Product Change Notice (PCN)

PCN Number: PCN-0450882R-01

Product(s) Affected: *PJ1-022-SMT-TR*

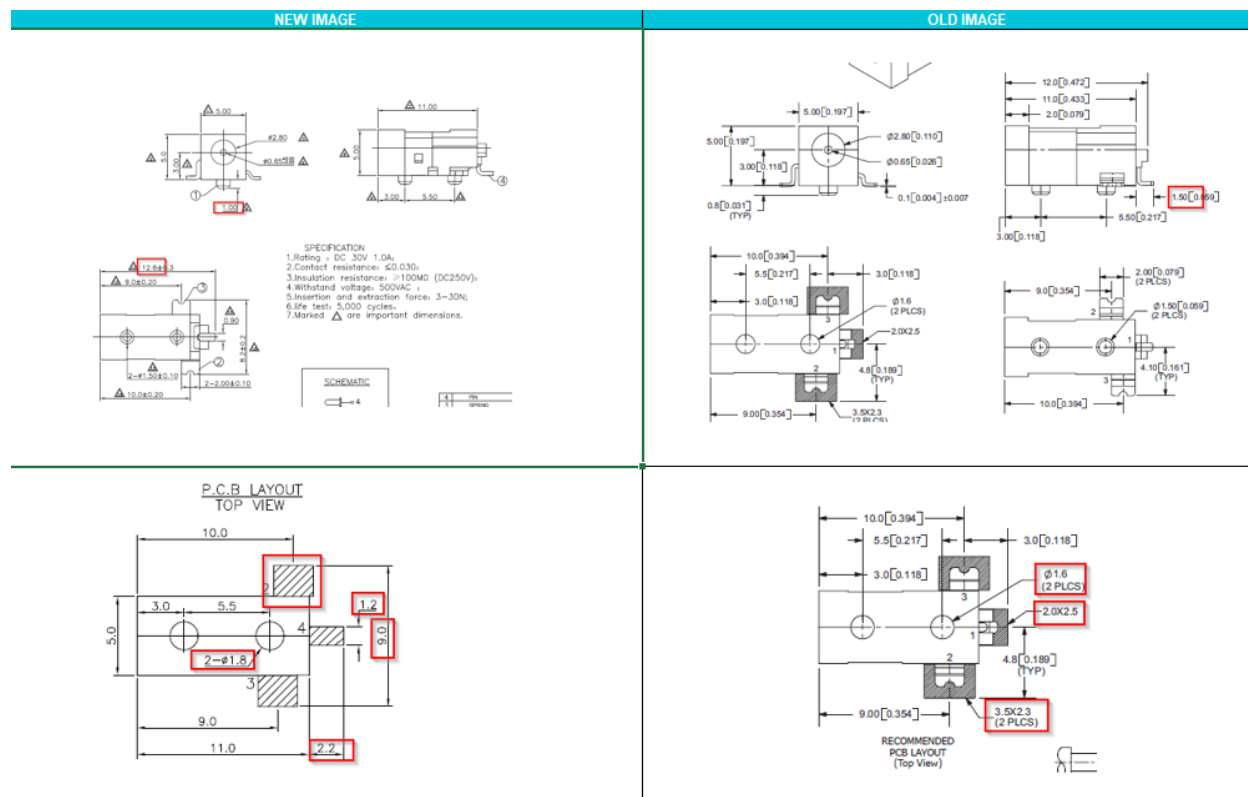
Description of Change: *Minor Housing and footprint differences. Material Change on the housing and terminals. See image Below*

Housing and Terminal Material Changes:

Center Pin: Brass to Bronze
Terminal 2: Copper Alloy to Brass
Plastic: PA6T or Equivalent to PA10T
